SAFETY RECALL BULLETIN

AUTOCAR SAFETY RECALL A-0806
NHTSA RECALL 08V-612

SUBJECT: ACX BRAKE TIMING

**VEHICLES AUTOCAR RH-DRIVE ACX-
AFFECTED: MODEL VEHICLES BUILT WITHIN
DATE RANGE 03 APRIL 2008 TO
17 SEPTEMBER 2008, WITHIN VIN
RANGE 207236 TO 208368**

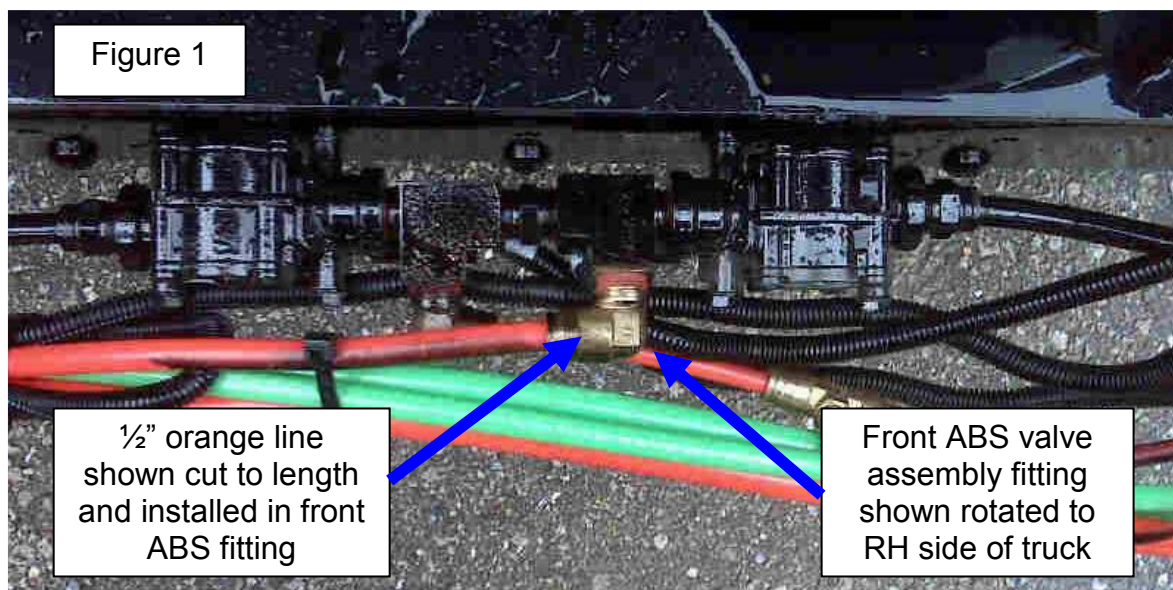
NOTE: Throughout the repair process, consult the routing schematics pictured in this Repair Procedure to ensure that modifications are made to the correct air lines and fittings.

Step 3: Remove both ends of the $\frac{1}{2}$ " orange air line routed from the chassis manifold to the $\frac{1}{2}$ " 90-degree fitting mounted on the front middle of the front

Step 6: Rotate the $\frac{1}{2}$ " 90-degree fitting on the front ABS valve to the RH side of the truck using adjustable wrench. See Figure 1 showing rotated fitting.

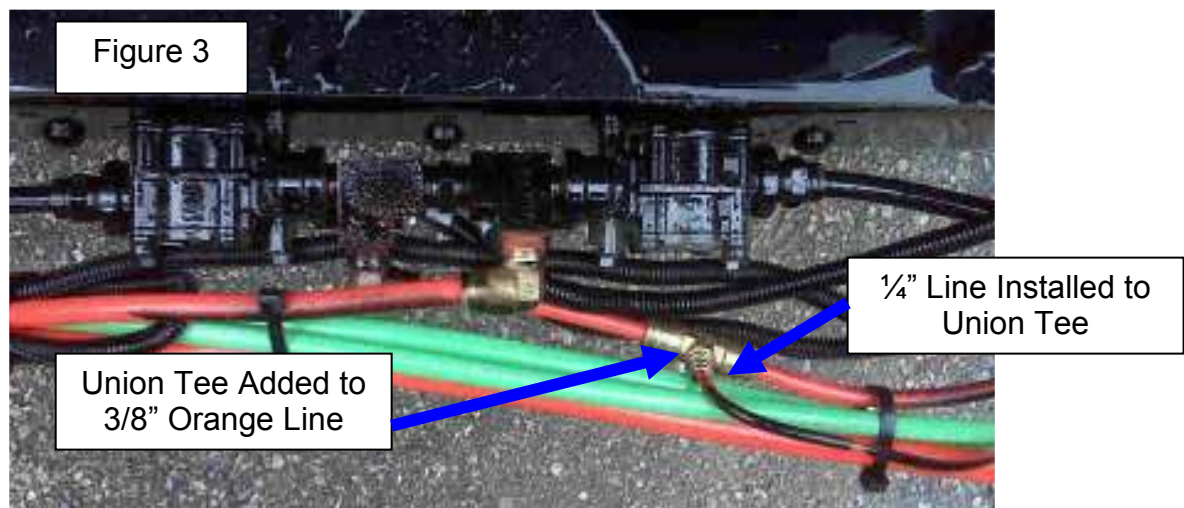
See Figure 1 showing the 1/2" orange air line cut and installed to the front ABS fitting.

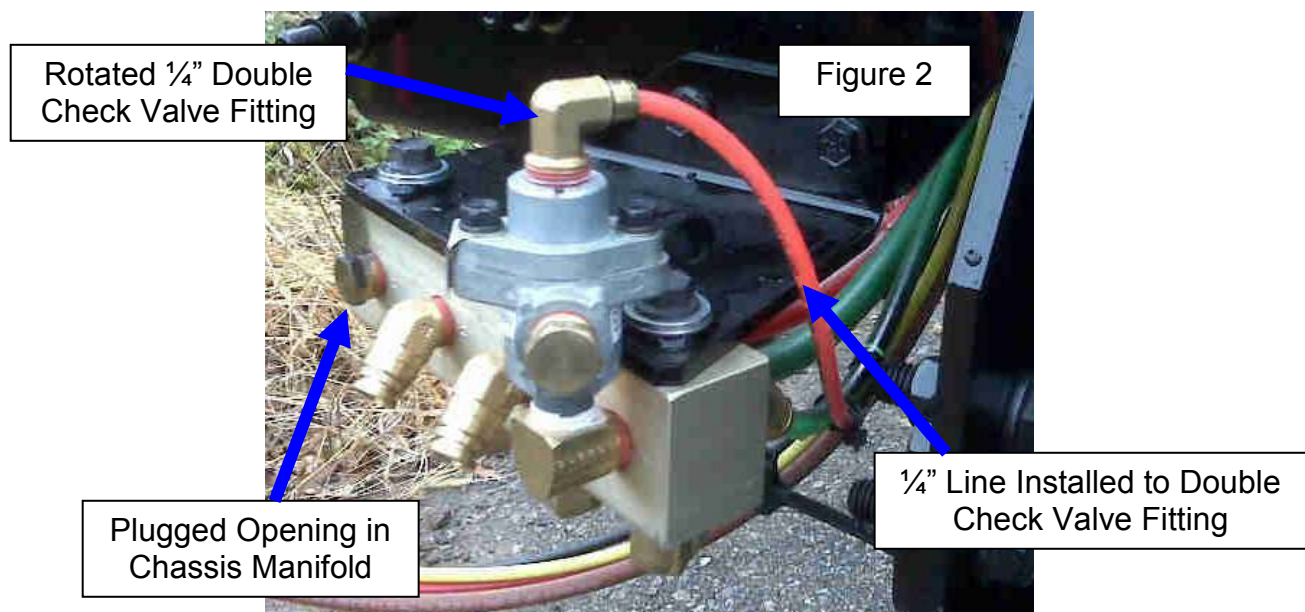
Step 13: Install 3/8" NPT plug into open hole in chassis manifold using adjustable wrench. See Figure 2 showing plugged hole in chassis manifold.

Step 15: Rotate 1/4" fitting on chassis manifold double check valve inward towards airlines routing from chassis manifold. See Figure 2 showing rotated 1/4" double check valve fitting.

Step 16: Install 1/4" orange line from 1/4" fitting on chassis manifold double check valve to 1/4" fitting on union tee. See Figure 2 and Figure 3 showing 1/4" orange line routed from double check valve to union tee.
